Ruhe Subdivision

Minor Plan 2013-201

Memorandum

SUBJECT: Ruhe Subdivision
Minor Plan 2013-201
PRELIMINARY/FINAL PLAN REVIEW

WATER SYSTEM PLAN AND PROFILE

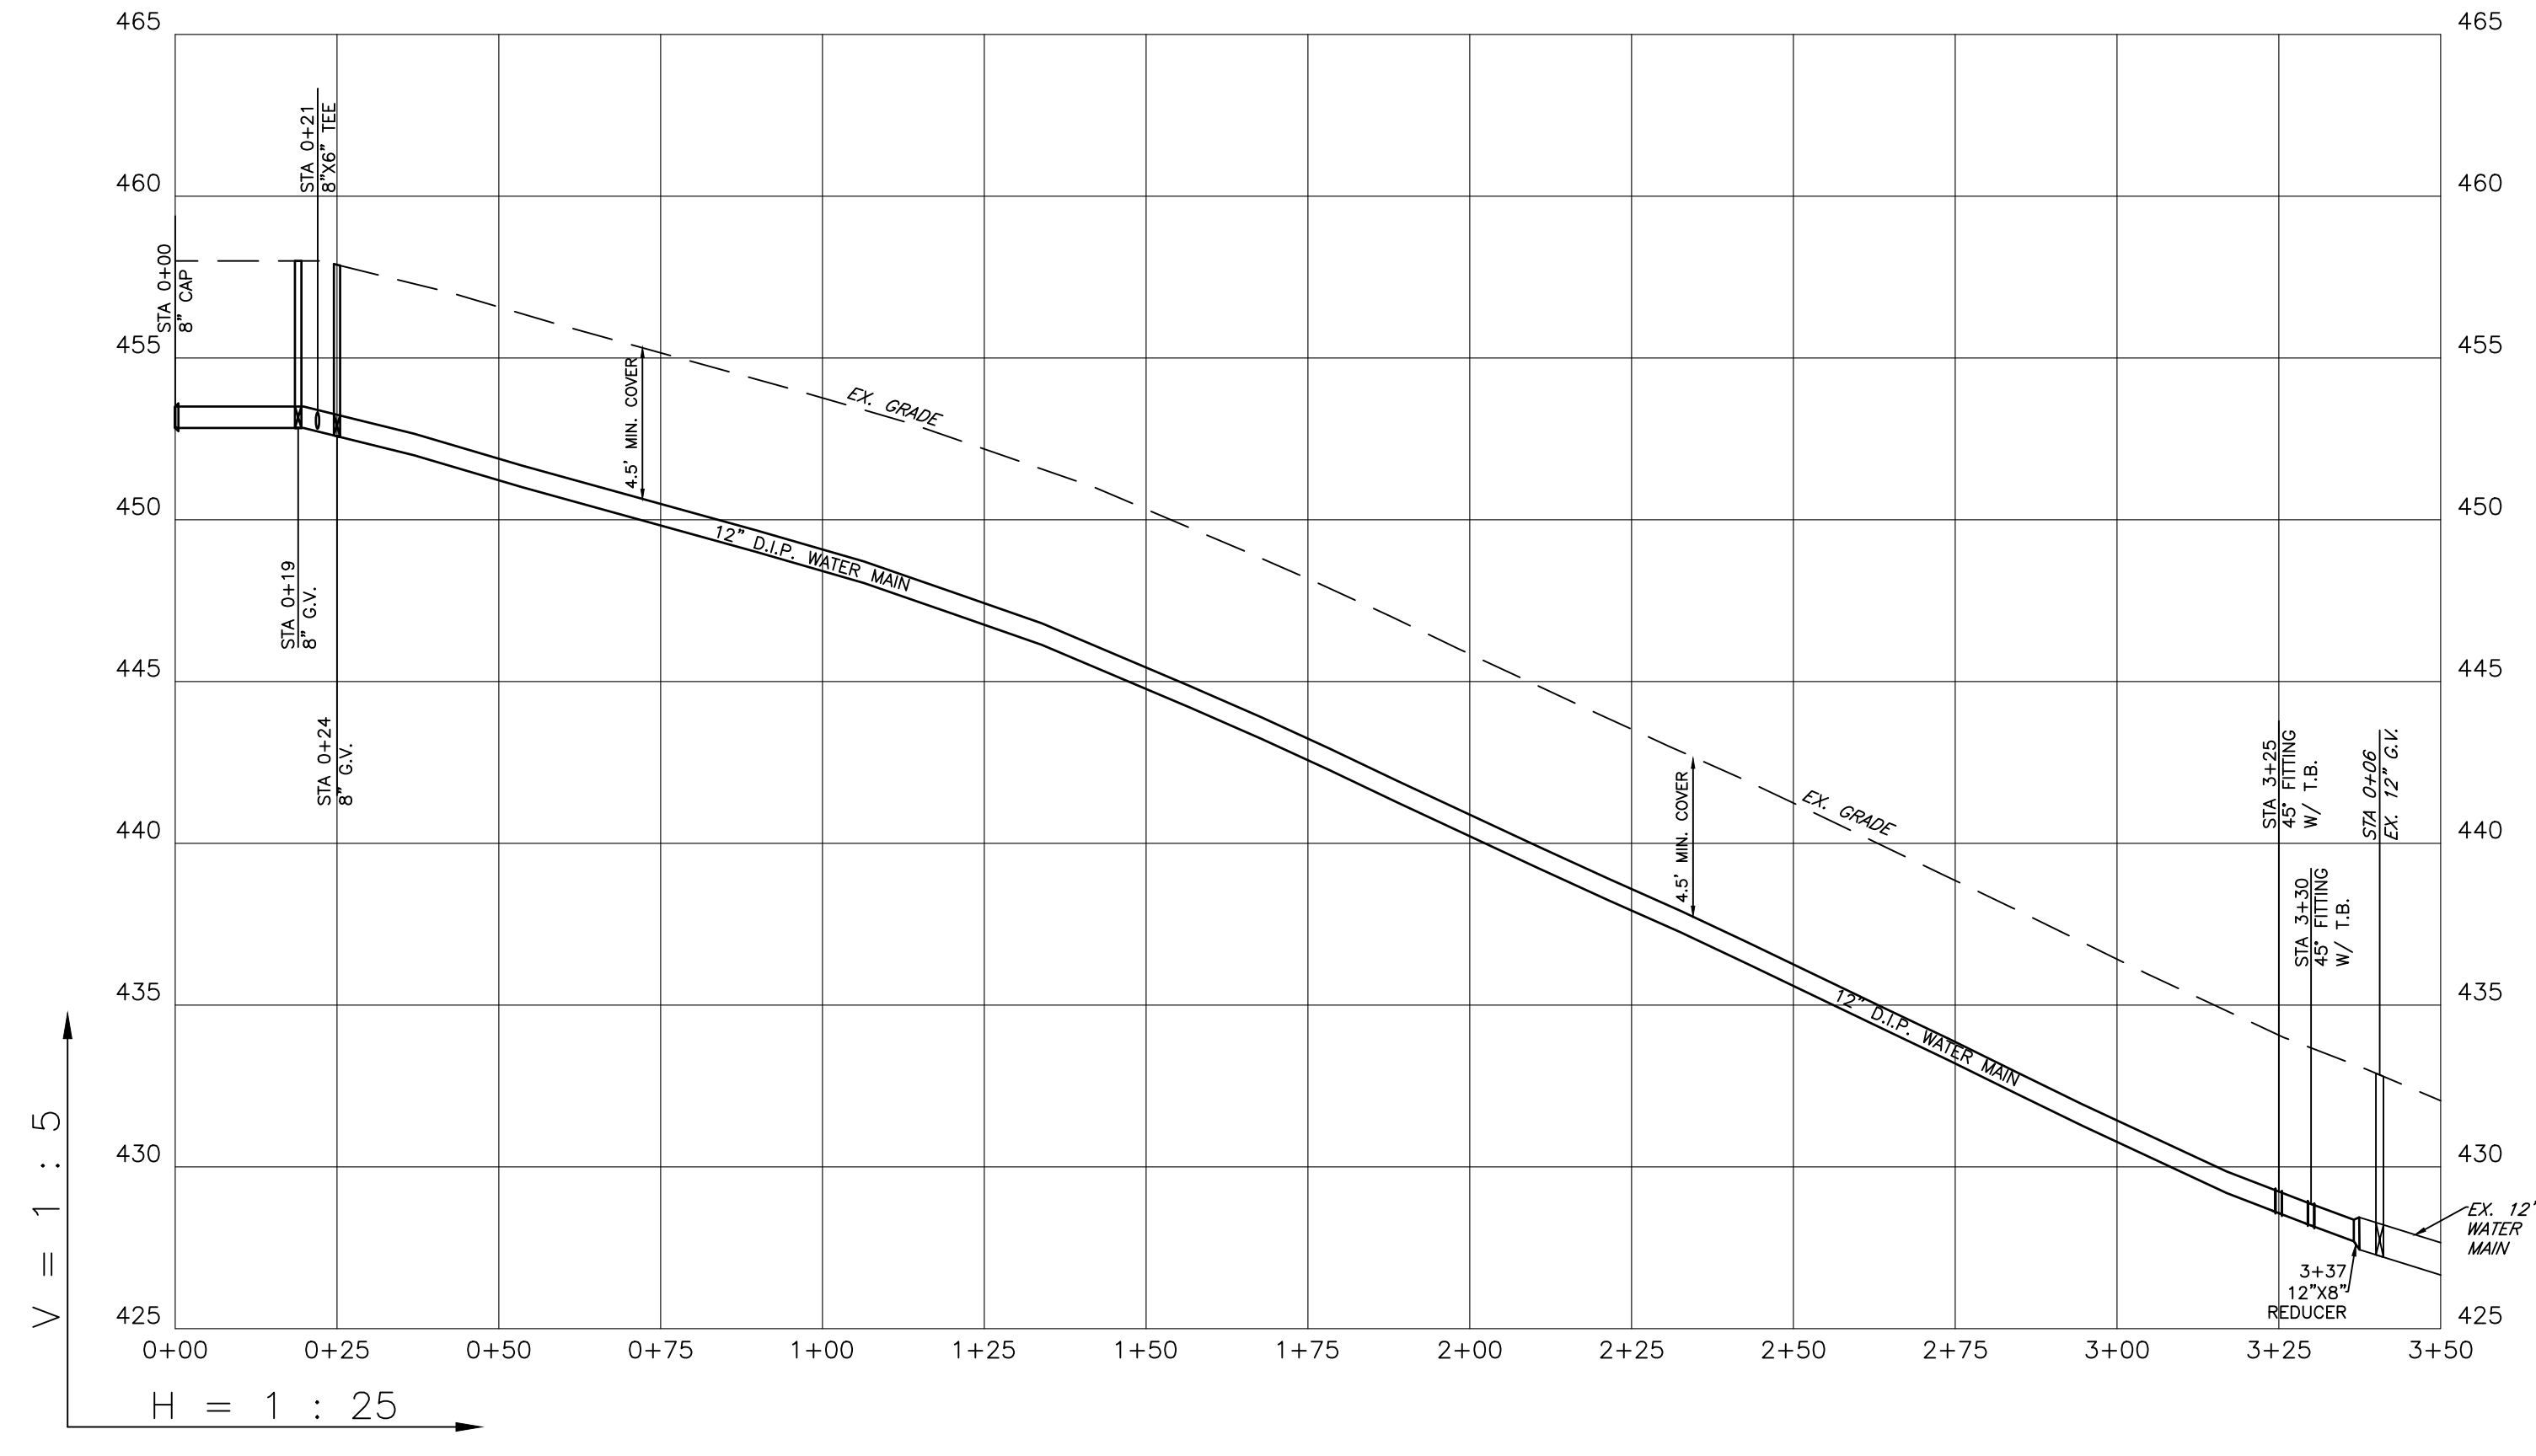
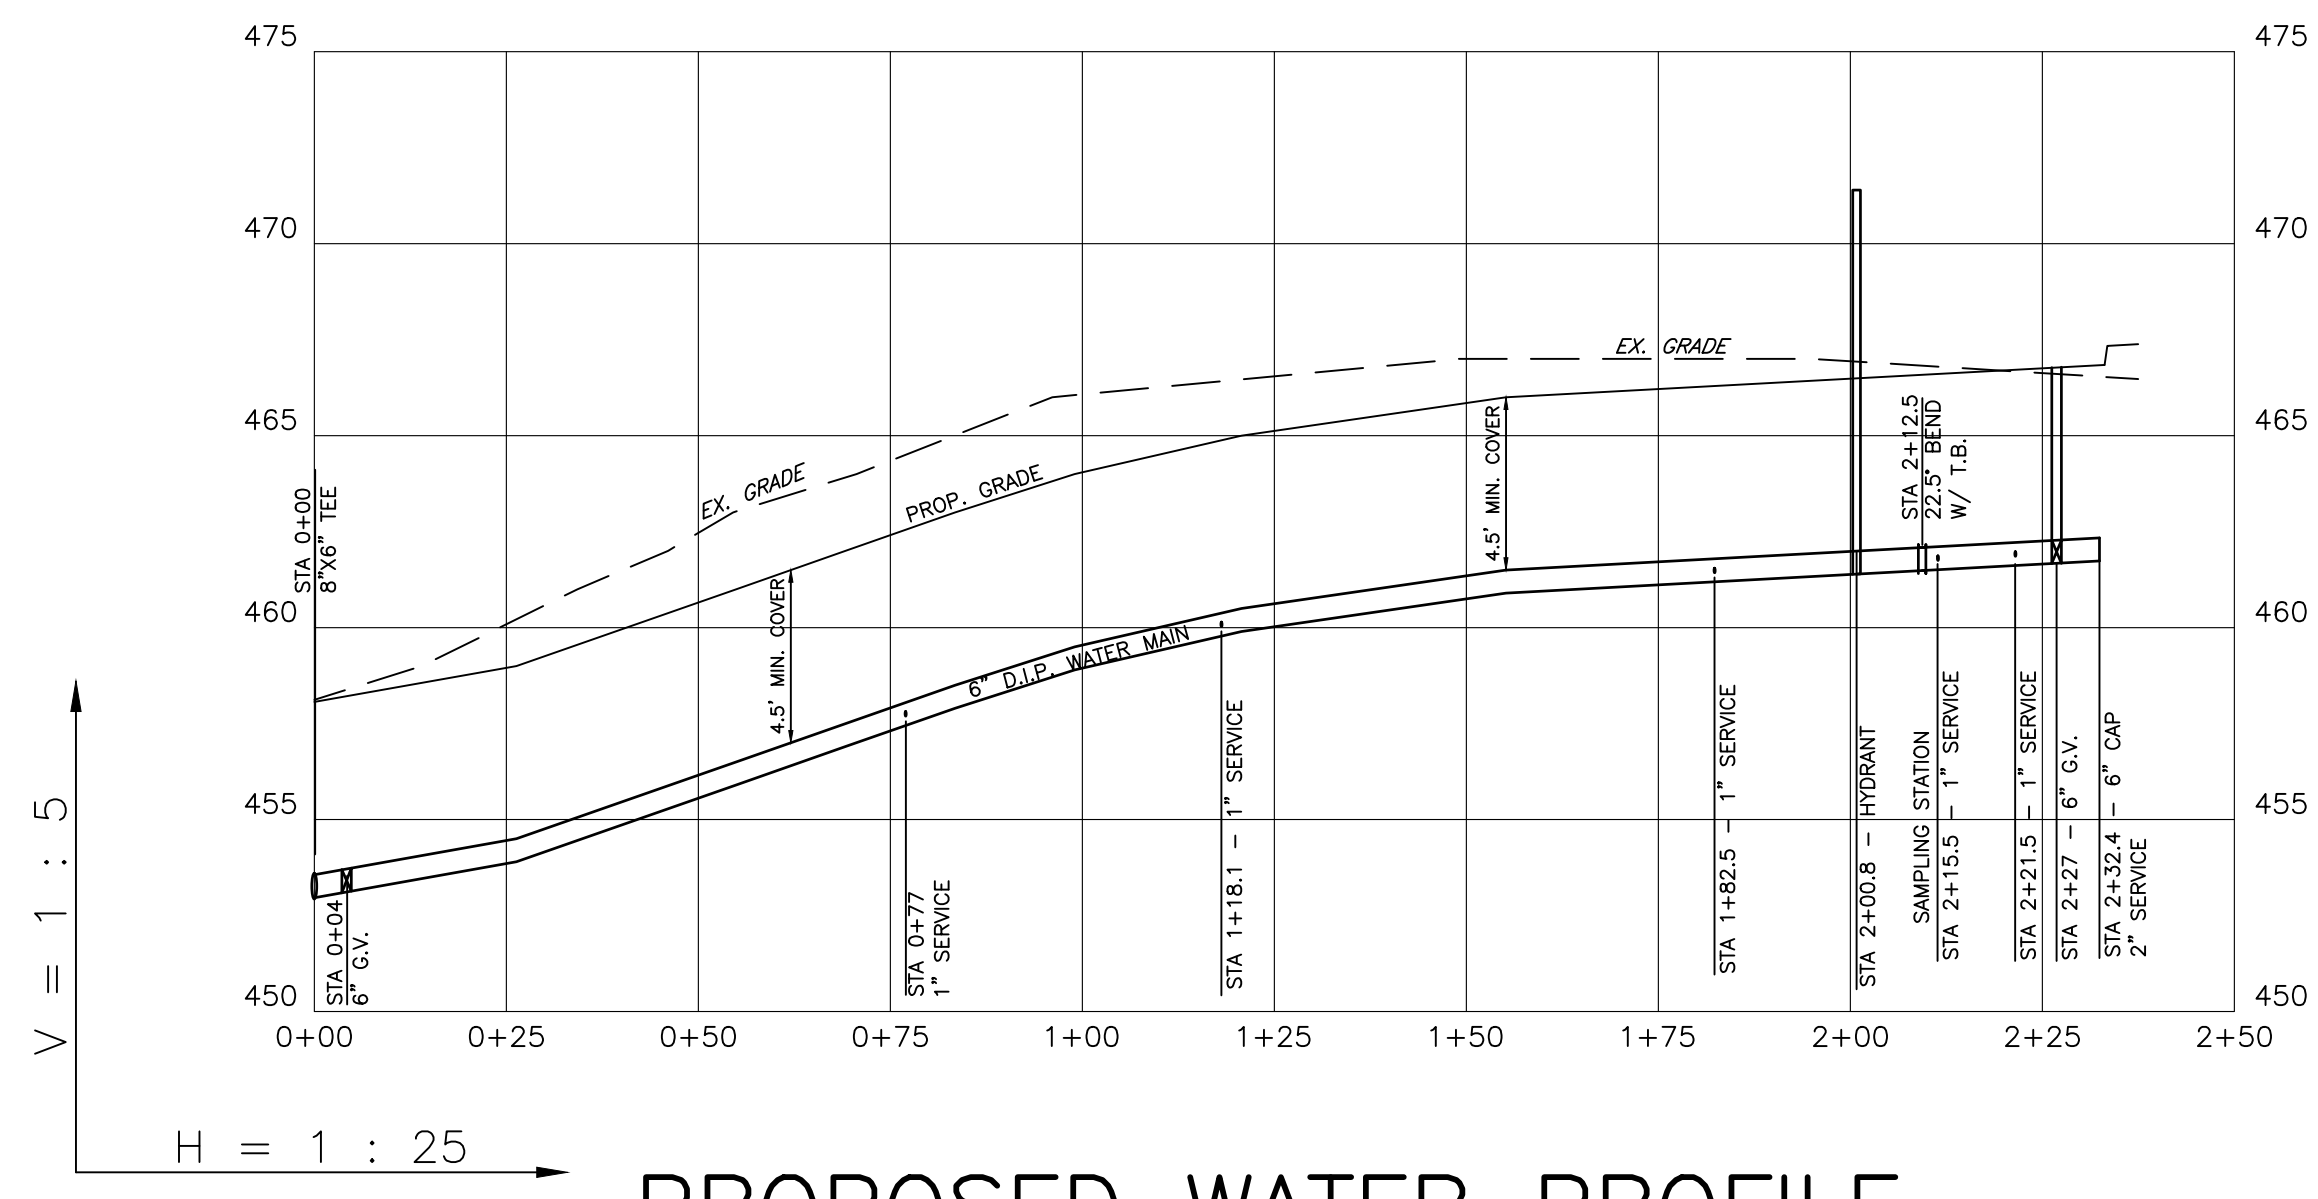
2. **Water system Plan and Profile: Sheet 14 of 23:**
